## MORAY COUNCIL

### PLANNING CONSULTATION RESPONSE

**Planning Application Ref. No: 10/02055/APP**

**Erection of hotel at Easter Coltfeld Farm Alves Moray for Mr Peter Smith**

### Single Track Roads - Typical Infrastructure

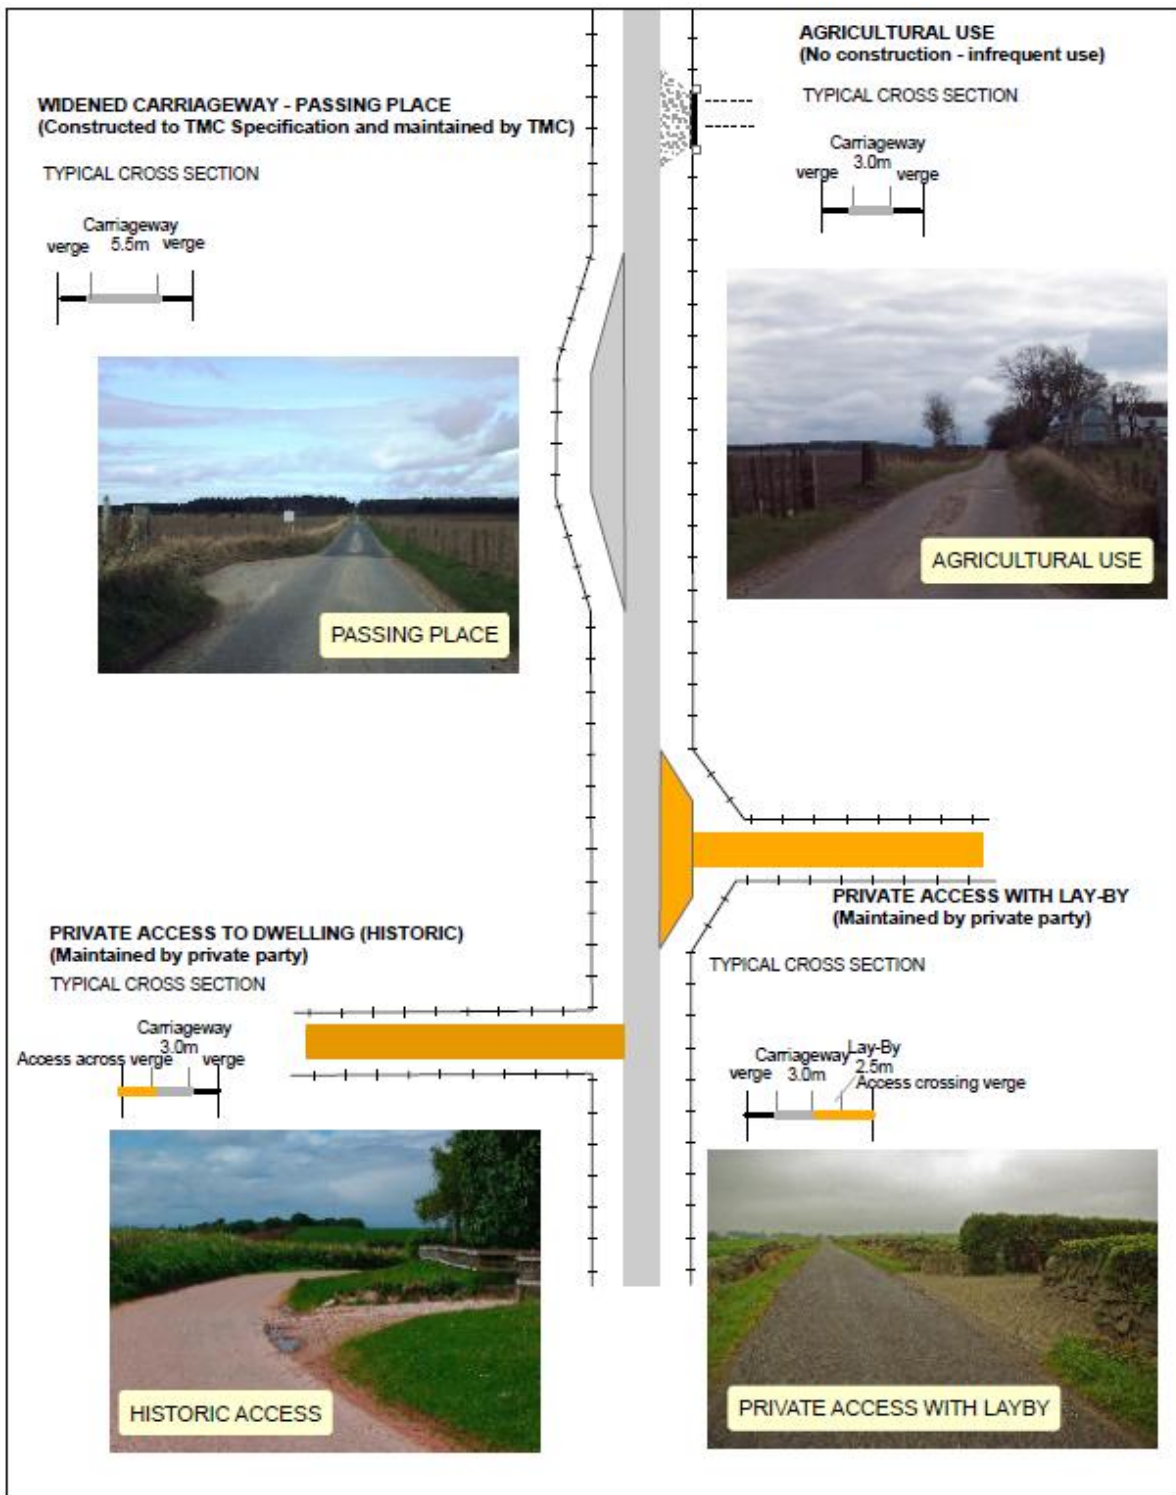
In section 4 of the TS the consultant refers to ‘informal passing places’ without any explanation or identification of the locations. During discussion with the consultant the differences between agricultural access, private access and passing place were explained. Subsequent to the meeting and receipt of the TS a diagram showing the typical infrastructure on single track roads has been prepared. The diagram shows the differences between each infrastructure item. Private accesses are not passing places. A copy of the diagram is attached to this document.

# 10/02055/APP Assessment of Passing Places

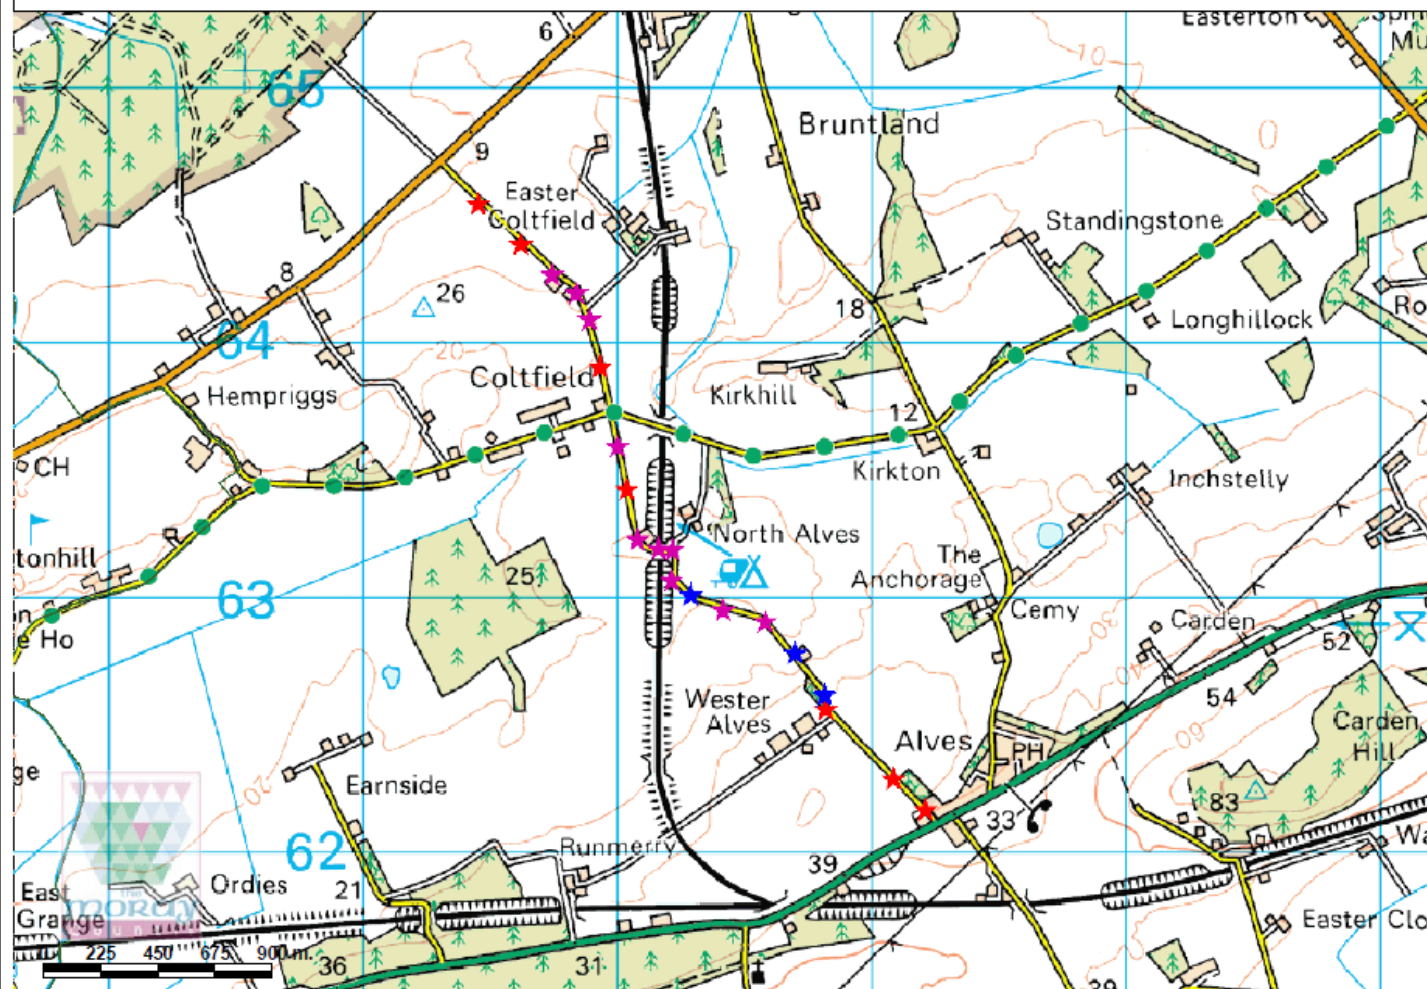
Through an assessment of the single track road in relation to passing place provision (distances between the existing passing places, the intervisibility between the passing places and the locations where there is restricted forward visibility) there are an additional 10 passing places required. A copy of the passing place plan is attached to this document. Discussion with the consultant confirmed that locations with extremely restricted forward visibility, such as the bend where the U58E crosses the disused railway line, have a higher priority compared to passing places on a straight section of road. However, it was confirmed that all passing places were required to provide a suitable and safe access. The TS suggests that 3 priority locations might be acceptable for the proposed development - this is not the case.

- Provision of 10 new passing places; and
- road widening to at least 5.5 metres along part of the frontage of the site (north of the Site Access to Coltfeld Crossroads)
